# Access Compliance Report

## Public Rights-of-Way

Intersection ID: 32276	Main Street: SULLIVAN_RIDGE_DR	Cross Street: WILLOUGHBY_RUN_DR	Location: NE
ADA ID: DEEC862BE08A	Ramp Type: PerpDiag	Initial Pass/Fail: Fail	Overall Compliance: No
Severity Score: 46.25			
Codes/Mitigation Info/Possible Solution		Field Measurements/Component Compliance

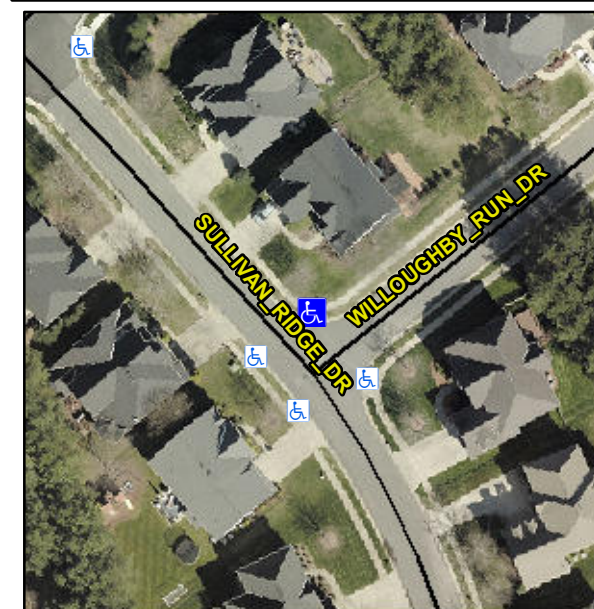
**Not Found, R304.5.1, R304.2.2, R304.5.3**

Compliance	Description	Data	Compliance	Description	Data
N/A	Ramp Length (in)	96.0	No	Ramp Slope (%)	9.9
No	Ramp Width (in)	37.5	No	Ramp XSlope (%)	7.7
N/A	Flare Type LT	N/A	N/A	Flare Type RT	N/A
N/A	Flare Slope LT (%)	N/A	N/A	Flare Slope RT (%)	N/A
N/A	Flare Traversable LT?	N/A	N/A	Flare Traversable RT?	N/A
N/A	Landing Length (in)	N/A	N/A	DWS Provided?	N/A
N/A	Landing Width (in)	N/A	N/A	DWS Contrast?	N/A
N/A	Landing Slope (%)	N/A	N/A	DWS Length (in)	N/A
N/A	Landing X Slope (%)	N/A	N/A	DWS Full Width?	N/A
N/A	Landing Curb? (Y/N)	N/A	N/A	DWS Offset (in)	N/A
N/A	Shared Landing?	N/A			
N/A	Gutter Ponding?	N/A	N/A	Gutter Slope (%)	N/A
N/A	Gutter Lip Ht (in)	2.0	N/A	Gutter X Slope (%)	N/A
N/A	Painted X Walk1?	No	N/A	Painted X Walk2?	No
	X Walk 1 Direction	To SW		X Walk 2 Direction	To SE
N/A	X Walk 1 Width (in)	N/A	N/A	X Walk 2 Width (in)	N/A
	X Walk 1 Slope (%)	0.9		X Walk 2 Slope (%)	2.0
	X Walk 1 X Slope (%)	4.0		X Walk 2 X Slope (%)	2.8

**Remove & Replace Curb Ramp With Two New Directional Ramps or Equivalent.**
